# Breakout Rev[F] SCH to PCB Differences

The schematic on p35 thru p42 of the Breakout Operation, Maintenance, Service Manual (TM-058, 4<sup>th</sup> printing) shows Rev[F]. This schematic does not perfectly match Rev[F] circuit boards. This document details the differences. Naturally we modify the schematics to match the boards because the boards ... work.

Diff-1 @ [S#1-C6]: Suppress LH/RH during HSYNC (adds CR9\*, CR10\*, R59\*)

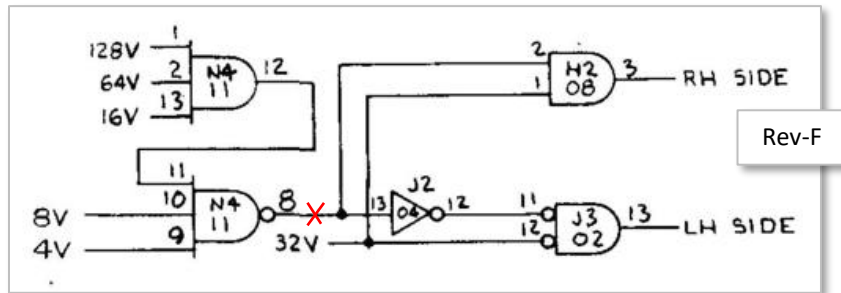
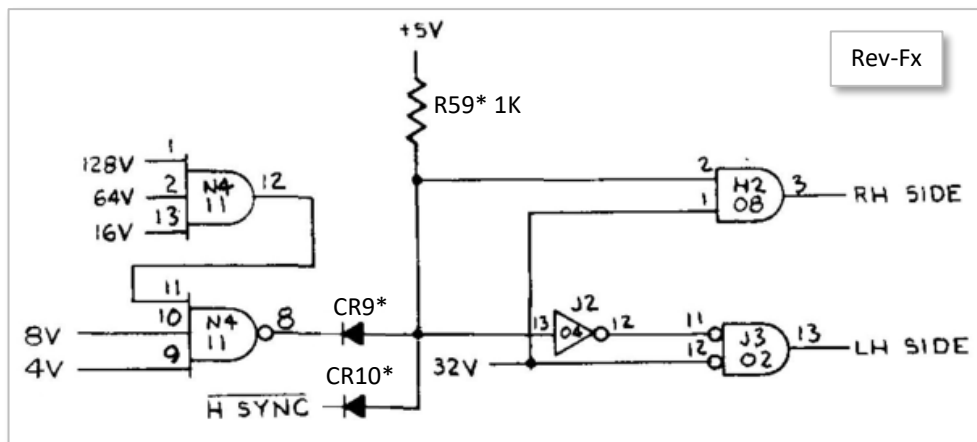
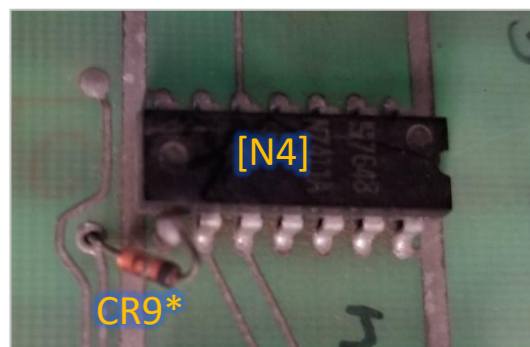
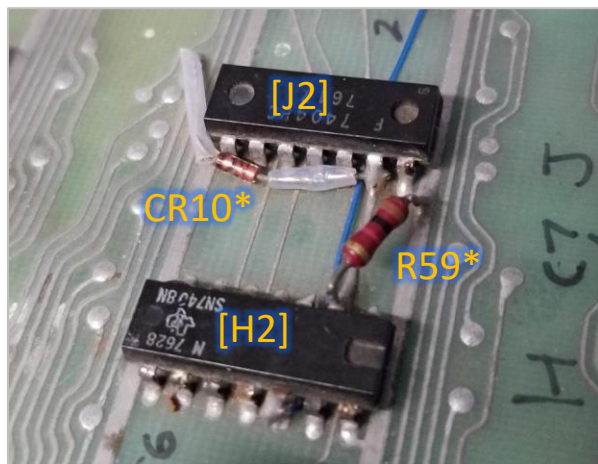
Net was cut and two diodes and a 1K resistor were added, effectively creating an AND gate (or negative-input NOR) to suppress LH/RH sides during !H\_SYNC.

You can see part of this mod on the rev-D board as shown below. This is built into rev-E boards. ECN therefore should be 2525. Diodes are 1N914 and the resistor is 1K.

Diff-2 @ [S#1-A6]: Different wiring of the Set Bricks FF [D3b]

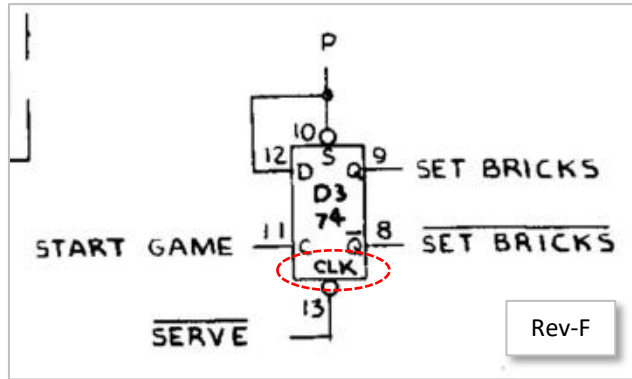
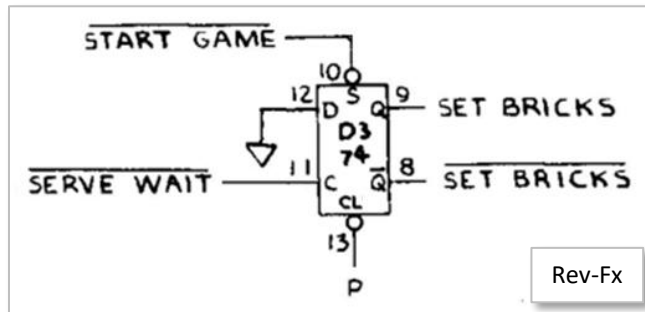
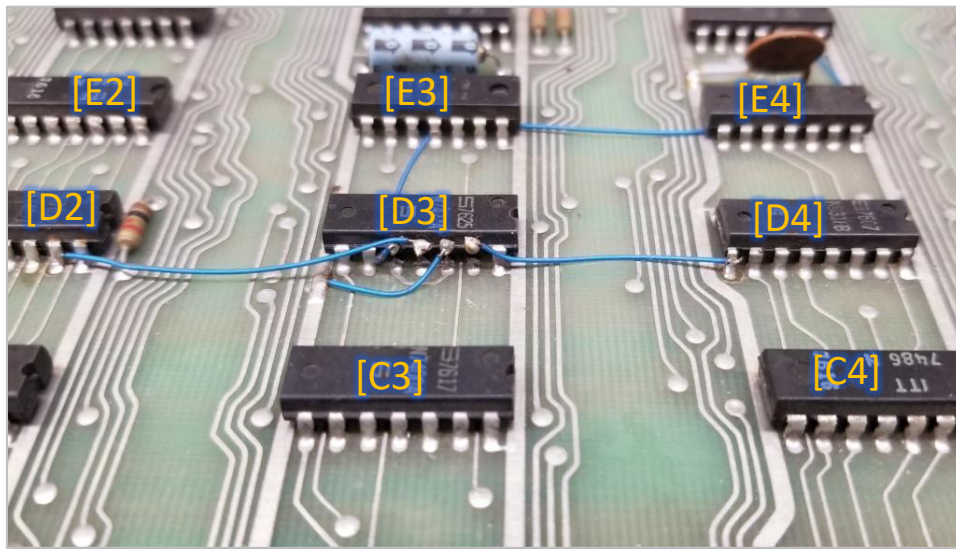
The set bricks driver FF is wired like this on the schematic:

But is wired like this on the PCB. Note that pin 13 is labeled CLK but is clearly CL[R].

You can see change this was a mod to a Rev-C board, but is present in boards >= Rev-D:

Diff-3 @ [S#1-D3/D4] - Video Chain Resistor Differences

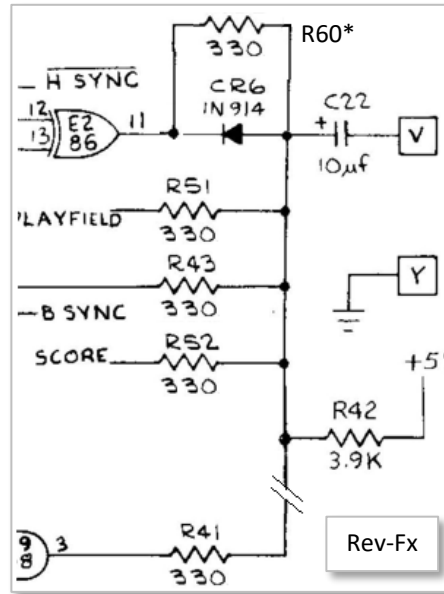
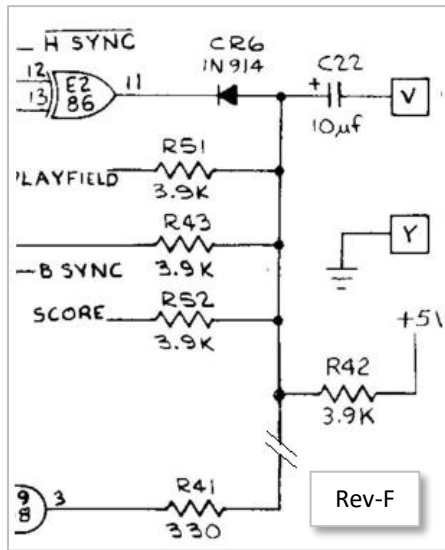
R41, R43, R51, and R52 on my ref-D board and in subsequent images are 330 ohms (R42 remains @ 3.9K). This increases the white level of the video signal. Another 330 ohm resistor was also added over CR6 (effectively removing CR6 function).

You can see the new resistor soldered over CR6 on my ref-D board (left) and a new place for this resistor on a rev-E board. Again, the ECN should be 2525.

Diff-4 @ [S#1-C2]: Play FF [F5a] Cleared by HSYNC instead of 128H

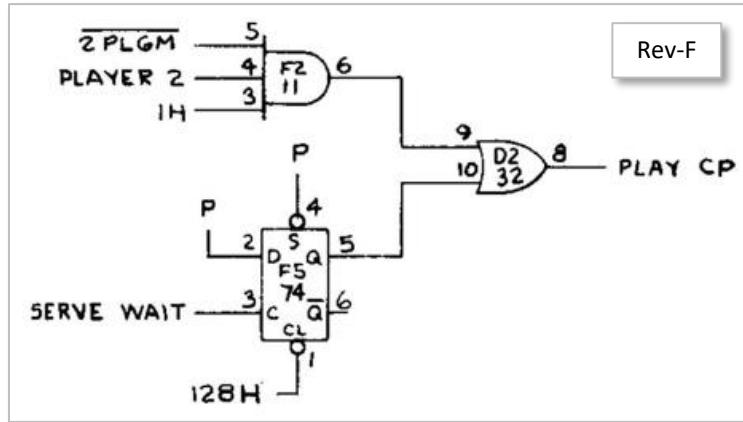
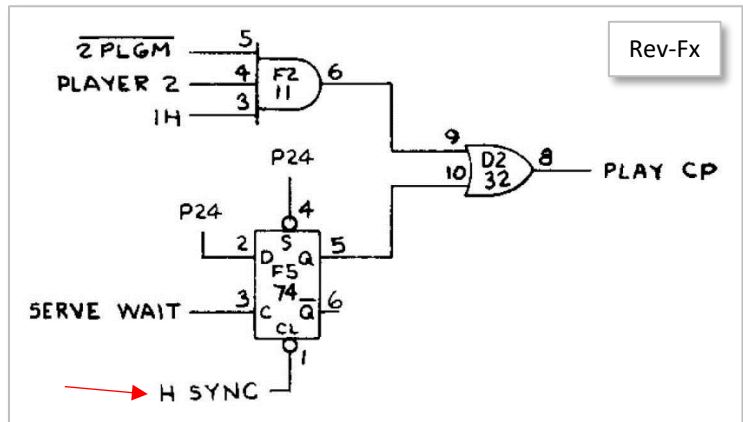
FF Clear is driven by 128H on the schematic.

But is wired to H\_SYNC on the PCB

Diff-5 @ [S#1-B4]: Different Wiring in Ball Motion Logic

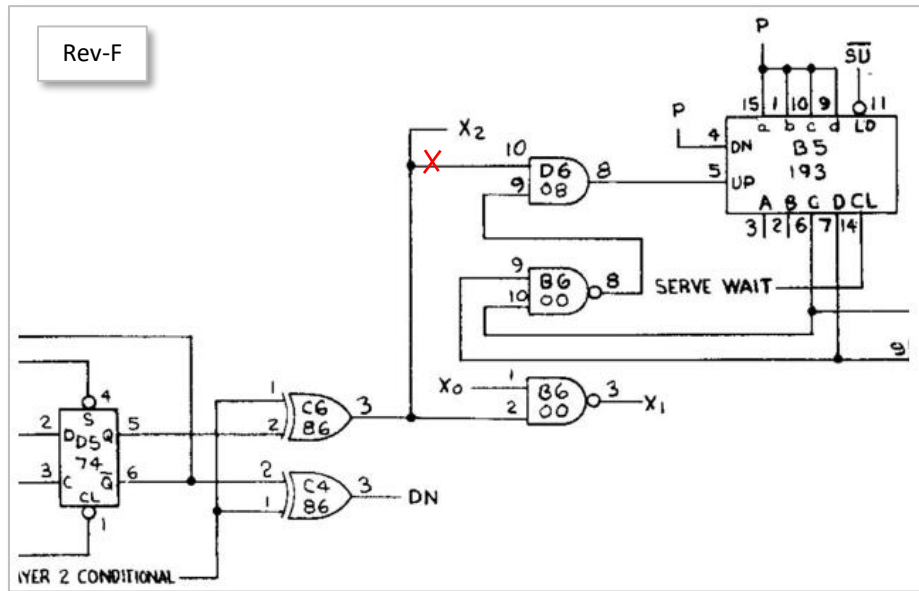
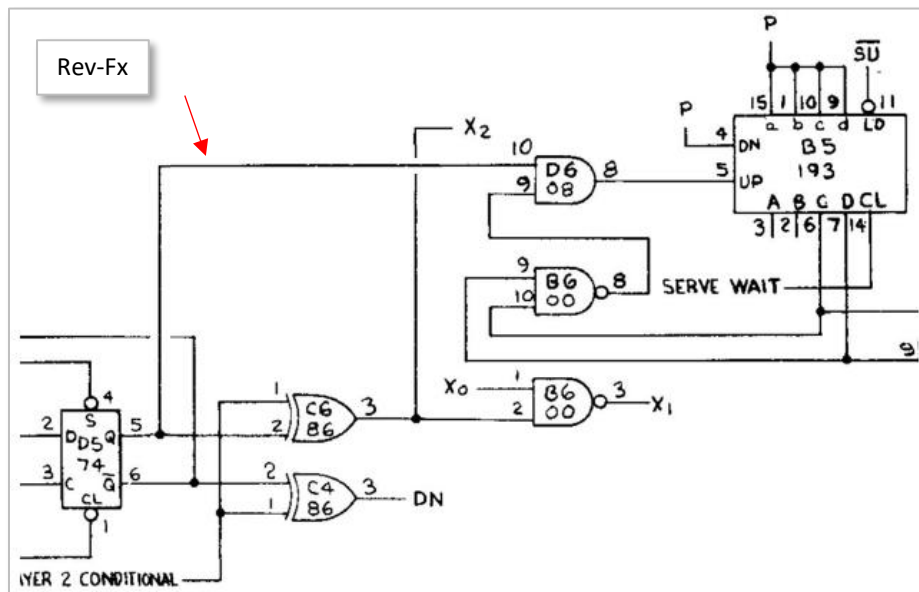
X2 into D6.10 comes off C6.3 on the schematic.

But D6.10 is driven by D5.5 on the PCB. This only takes effect when player 2 is up on a cocktail machine. Using the rev-F schematic, the ball is shot quickly towards player 2. We don't see this behavior in FPGA derivatives because 2-player cocktail models are never implemented (that I've seen).

Diff-6 @ [S#1-B1/2]: Serve Wait Logic Differences & Add 330pF Cap C39\*

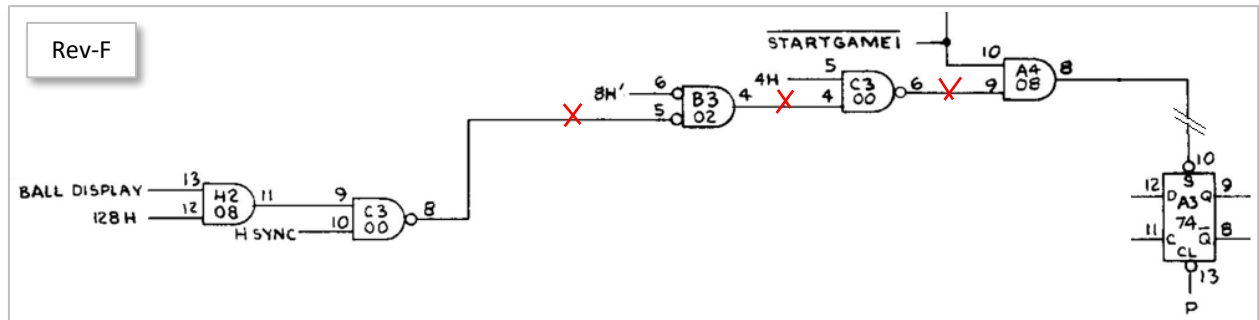
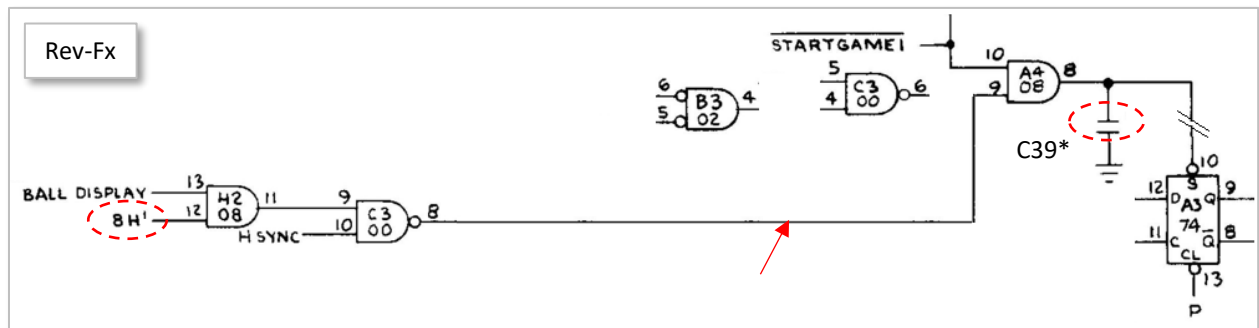
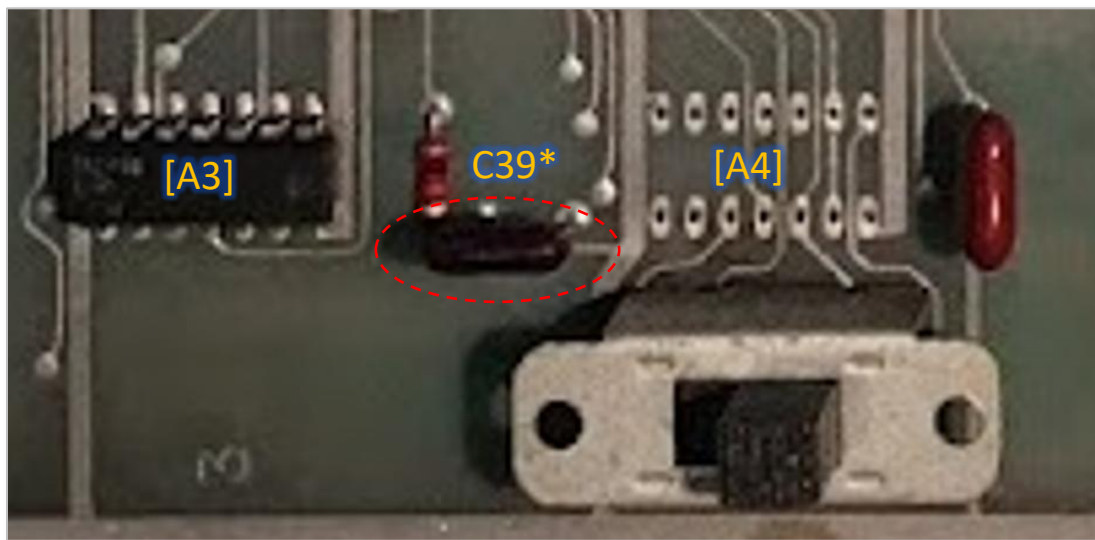
The serve wait FF [F3b] set logic looks like this in the schematic.

But looks like this on the PCB. Gates B3b(4,5,6) and C3b(4,5,6) are unused on the PCB (inputs should be tied down or pulled up). Gate H2 pin 12 is tied to 8H' on the PCB, not 128H as shown in the schematic.

There is also a cap present at site A3/A4 on ref-F board shown below, connected to A4.8 as shown in the revised schematic above. This is not present on my Rev-D (mod or otherwise), but is present as a mod on #3877 (assume rev-E). No clue what the value is. Looks the same as the other 0.001uF caps, e.g. C37.

Diff-7 @ [S#1-B1/B2]: Another Serve Wait Logic Difference (adds a 7408 @ [C1\*])

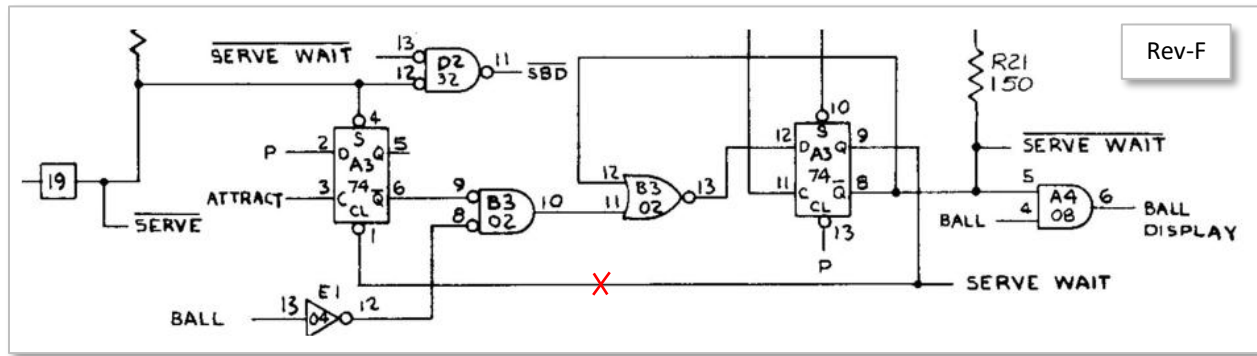
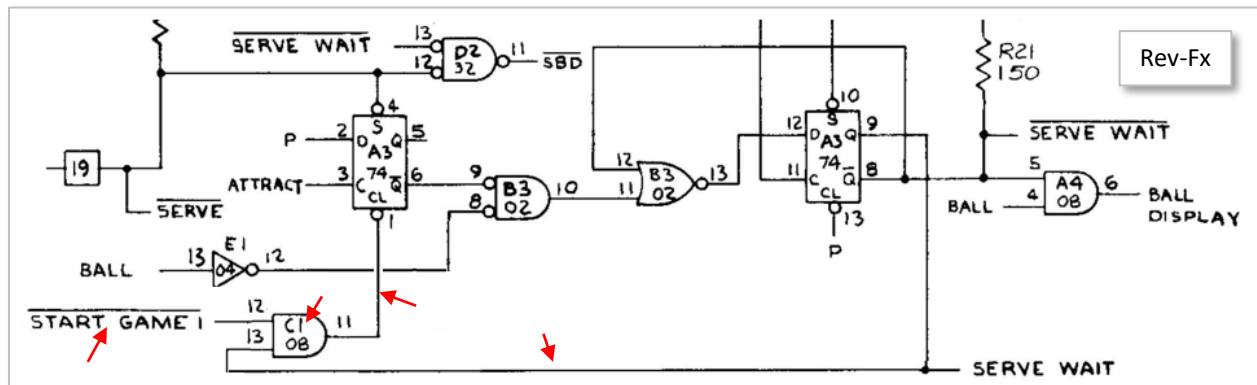
Site C1 is clearly populated on most PCBs but there are no C1 gates on the schematic. Only one gate is used. This mod allows the !START\_GAME signal to reset FF A3a (blocks ball from attract mode). This modification is present in many early boards.

Logic as present in the schematic. A3a's CLR is wired to the SERVE\_WAIT signal driven by A3b-Q.

Logic as present on the PCB. Both SERVE\_WAIT and !START\_GAME\_1 drive A3a's reset pin.

## Diff-8 @ [S#2-B2] - Paddle Wiring Differences

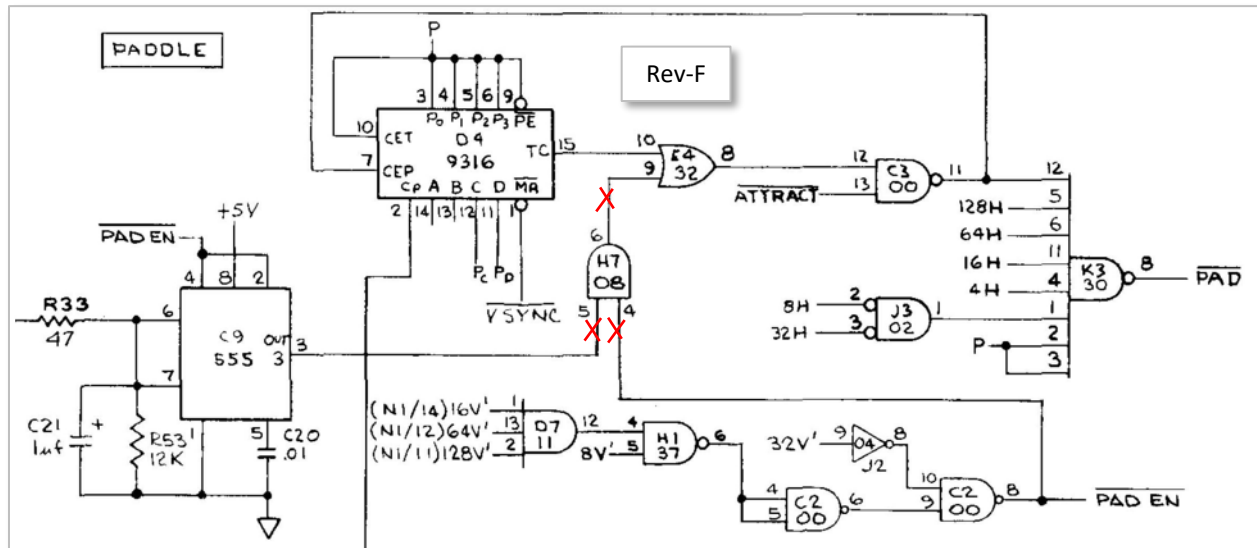
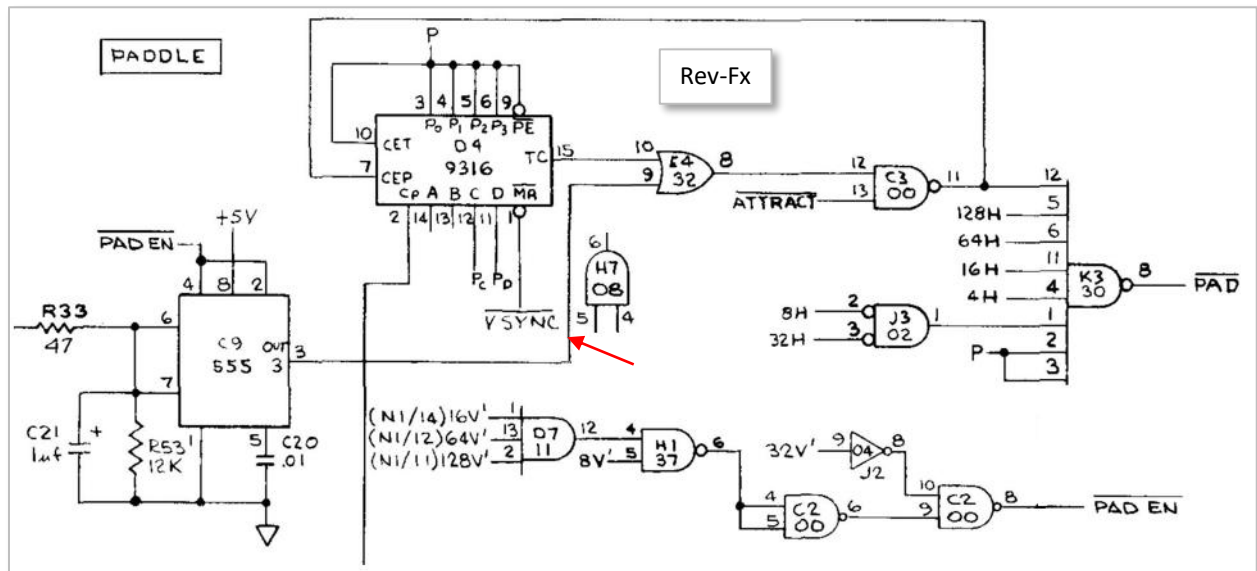
Schematic shows the output of C9 wired to H7.5

On the PCB, C9.3 is wired to E4.9 as shown below and gate H7b (4,5,6) is unused.

Diff-9 @ [S#2-B3] Paddle Timer Changes to 555 @ [C9] (adds C40\*)

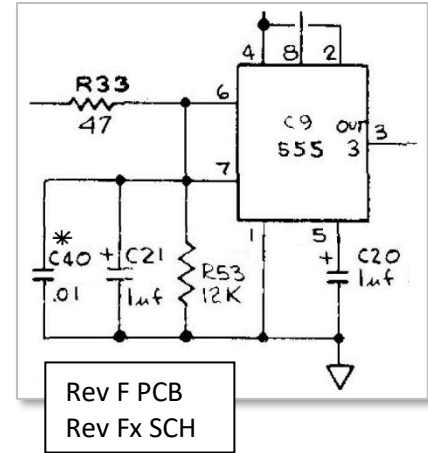
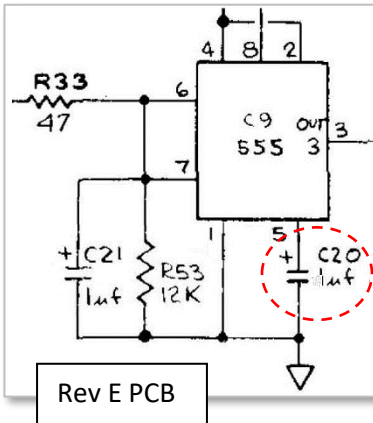
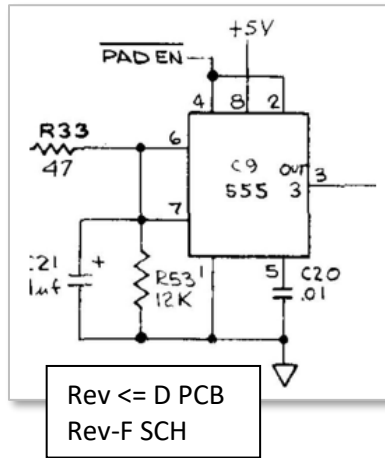
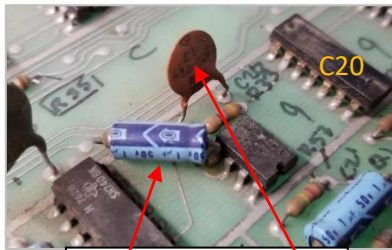
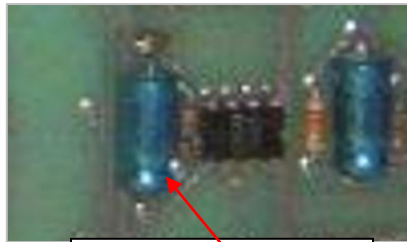
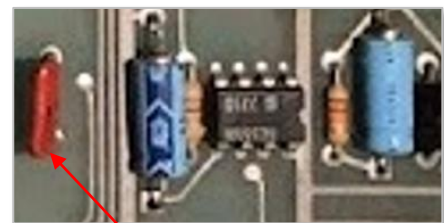
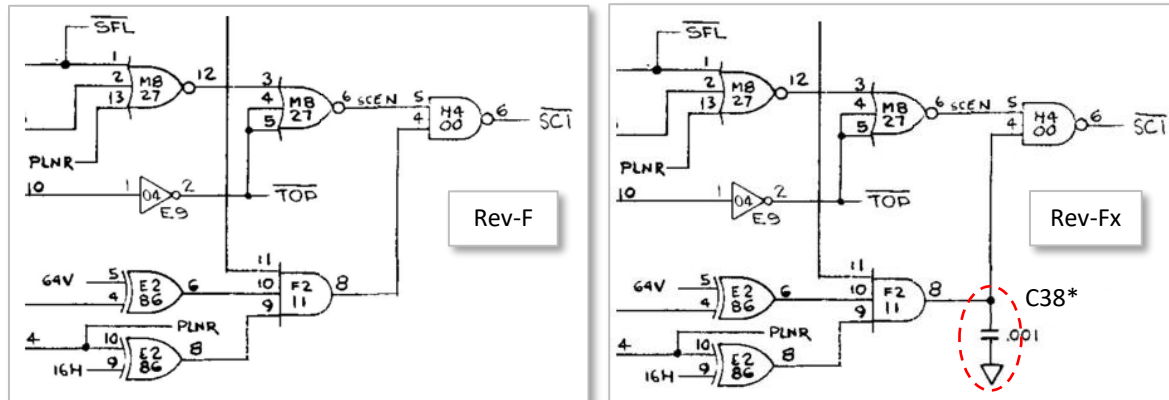
Schematic shows only one cap on L9.5 but the PCB and mods have 2. From the board images it looks like they first changed C20 to 1uF in Rev-E (but still 0.01 in Ref-F SCH), then added C40\* in Rev-F.

Here are board images showing a Rev-D with 1uF mod (over) C20, a Rev-D board with C20 changed to 1uF on the PCB, and a Ref-F board with an additional 0.01uF cap (C40\*) on the input line.

- In <= Rev-C the timing component values were different: R33 was 100ohm, C21 was 2.2uF, and R53 was 47K ohm.
- In <= Rev-C [C9] pin 2 (!RESET) was driven by !V\_SYNC , not !PAD\_EN.

Diff-10 @ [S#2-A4]: Add 0.001uF Capacitor in Score Logic (adds C38\*)

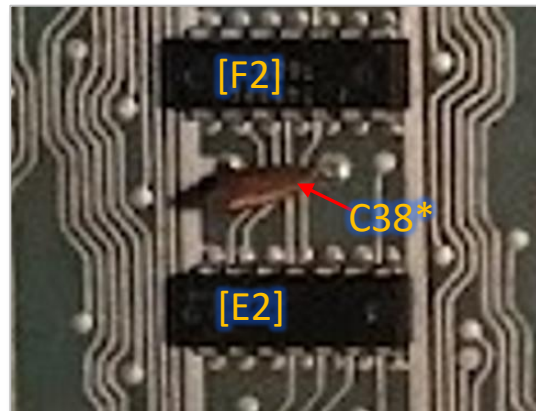
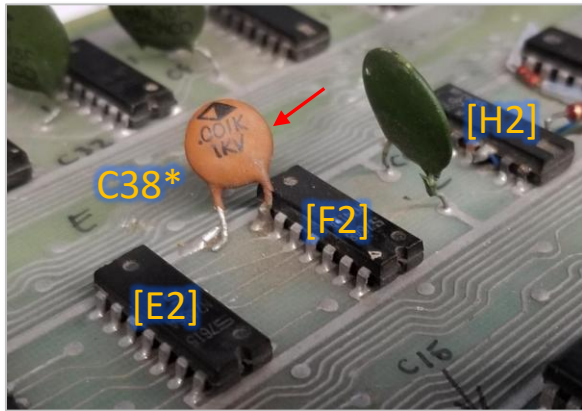
The PCB has a 0.001uF capacitor on K2.8 that is not shown in the schematic.

This is a modification on the rev-D board but is built-in on the ref-F board between [E2] and [F2]

Diff-11 @ [S#3-C7]: 1-Credit Start FF Wrong Signal Marking

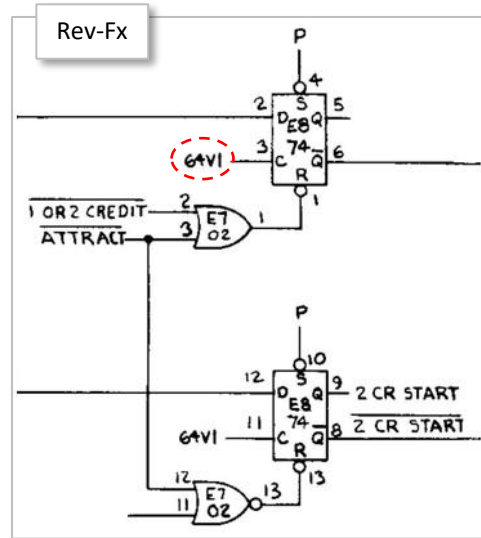
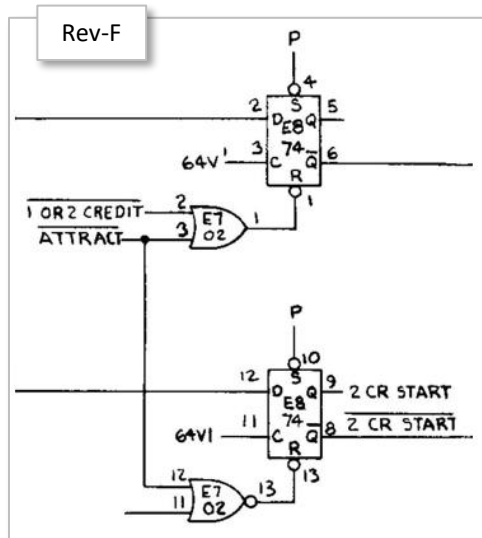
Schematic shows 64V' going into E8a.3 (FF clock) but this is 64V1 on the PCB. This is the same signal going into E8b.11 (FF clock). My guess is that they intended to use 64V' on both of these clocks because there is absolutely no reason you would want to change this coin logic signal when player 2 is up on a cocktail table.
